DOMINION NUCLEAR CONNECTICUT, INC.
MILLSTONE POWER STATION UNIT 3
RESPONSE TO REQUEST FOR ADDITIONAL INFORMATION
REGARDING PROPOSED TECHNICAL SPECIFICATION CHANGES FOR
IMPLEMENTATION OF ALTERNATE SOURCE TERM

PROPOSED TECHNICAL SPECIFICATION CHANGES
IMPLEMENTATION OF ALTERNATE SOURCE TERM
RESPONSE TO REQUEST FOR ADDITIONAL INFORMATION

DOMINION NUCLEAR CONNECTICUT, INC.
MILLSTONE POWER STATION UNIT 3

FIGURE 1
POST DBA MINIMUM CONTAINMENT SUMP pH

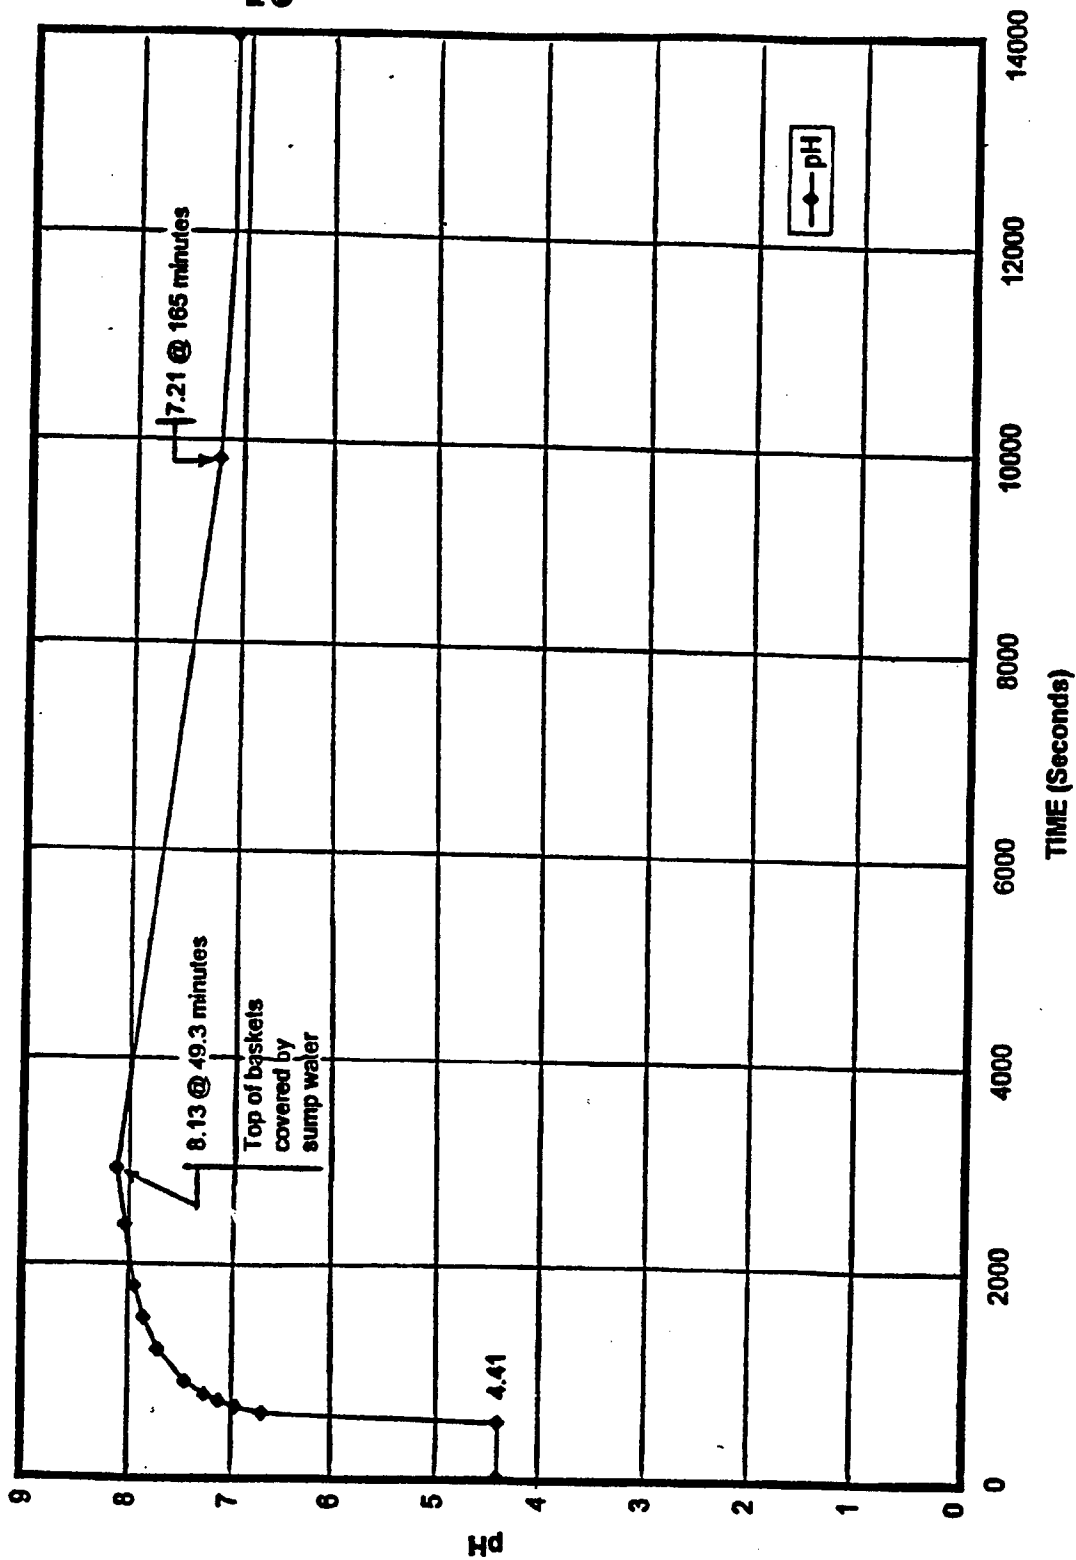
NRC Question 1D: Provide the results of the pH calculation at different time intervals and explain how the time intervals were selected.

DNC Response 1D: Enclosure 2 contains the profile of the post DBA minimum containment sump pH for the time period of LOCA initiation to 30 days following the LOCA. Time intervals were selected based on containment sump fill rates, changes to containment sump fill rates, and the additions of acids and bases to the sump solution. More points were selected early in the transient to ensure that a smooth curve could be generated. Since the generation of acids due to the breakdown of cable insulation and nitrogen is a long term effect and is relatively linear based on time and exposure level, fewer points were generated for the later portion of the pH curve.
